date: August 2, 2023
to: Jennifer Hofmeister-Drew, AICP, LCAM, Planner III,
Town of Palm Beach
from: Eric Czerniejewski, P.E., ENV SP
subject: Paramount Palm Beach Traffic Review

MEMORANDUM

The Corradino Group, Inc (Corradino) has been requested to provide a traffic review of the Traffic Impact Evaluation for the redevelopment of the Paramount Theatre located at 139 North County Road in the Town of Palm Beach, Florida. The following are our traffic review comments based on the 06/28/23 resubmittal.

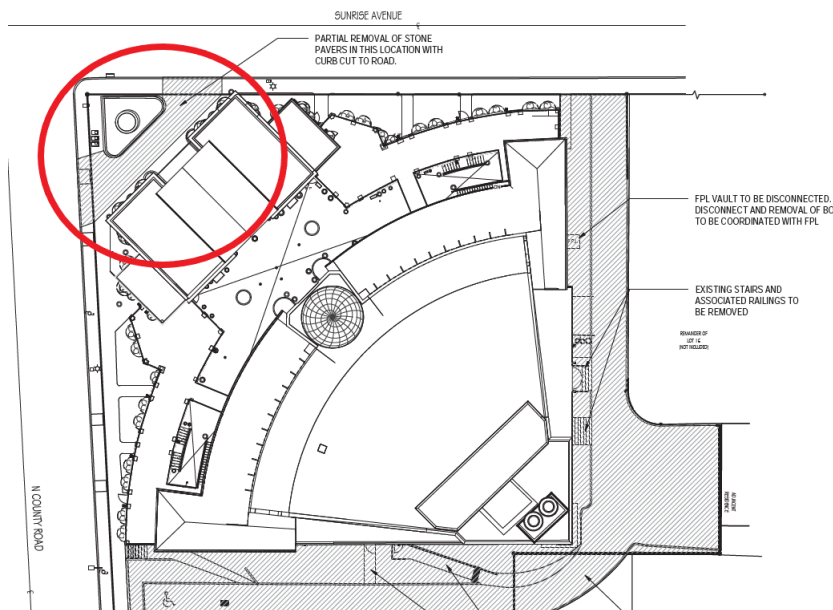
12. Please provide additional narrative that provides the total amount of queuing available from the valet stand to the adjacent road network for both scenarios. Figures 3 and 4 should be updated to denote the total amount of queuing available from the valet stand to the adjacent road network.

Kimley Horn and Associates, Inc.'s 03/09/23 Response Additional information is provided in the updated report and Figures 3 and 4 illustrating the queuing available to the adjacent road network. Note that the valet stand for the event space is proposed to be located on North County Road.

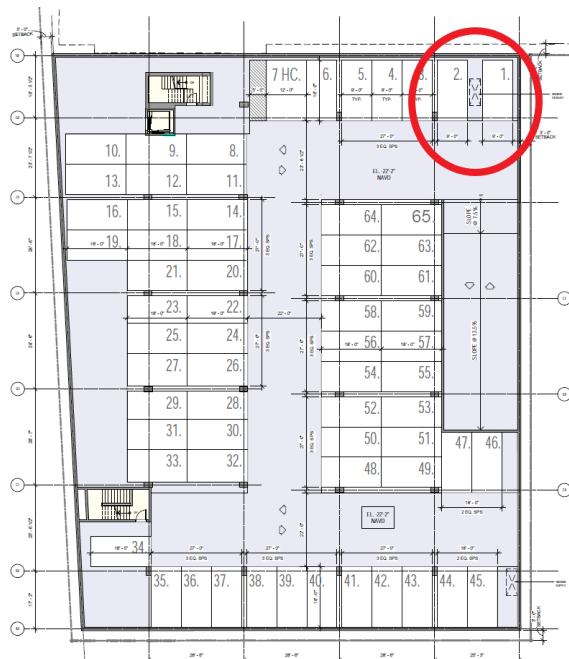
18. Please include a copy of the raw traffic counts from 11/29/22 in the Appendix of the updated traffic impact study. This traffic count data was not included as part of the traffic impact study dated 03/09/23. The Town of Palm Beach recently collected peak hour manual turning movement counts on 02/28/23 at the following three signalized intersections analyzed for the Paramount Palm Beach development:

1. Sunrise Avenue & N County Road
2. Sunset Avenue & N County Road
3. Royal Poinciana Way & N County Road

Please cross check the intersection capacity analysis completed as part of the updated traffic impact study utilizing this current traffic count data (copy of count data has been attached). Please update all tables and figures as necessary.

Kimley Horn and Associates, Inc.'s 04/18/23 Response: A copy of the raw traffic counts from 11/29/22 has been added to the Appendix. The two sets of traffic counts were compared, and there was not an overall consistent pattern between the two sets: volumes on some movements were lower, and volumes on other movements were higher when comparing the AM and PM volumes. Therefore, the Synchro analyses were not modified.

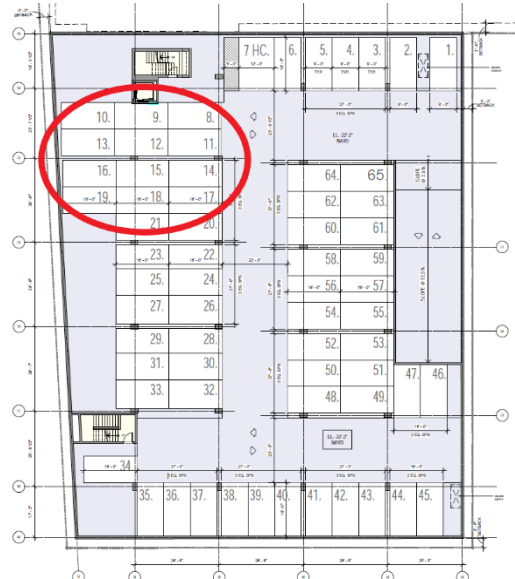
20. Please confirm how the proposed triple tandem parking spaces will be utilized by valet staff to ensure efficient parking operations while maintaining safe and efficient internal traffic circulation.

Kimley Horn and Associates, Inc.'s 04/18/23 Response: This condition was shown for only a total of four parking spaces and will only be used on infrequent occasions as it is anticipated that these would be the last parking spaces utilized only when other parking is full. Due to the minimal number and minimal usage of these spaces, it is anticipated that valet operators will be able to manage this parking during the few times in which they are in use.

TCG 08/02/23 Response: Addressed. A condition of approval needs to be considered to limit the use of these spaces to only when necessary.
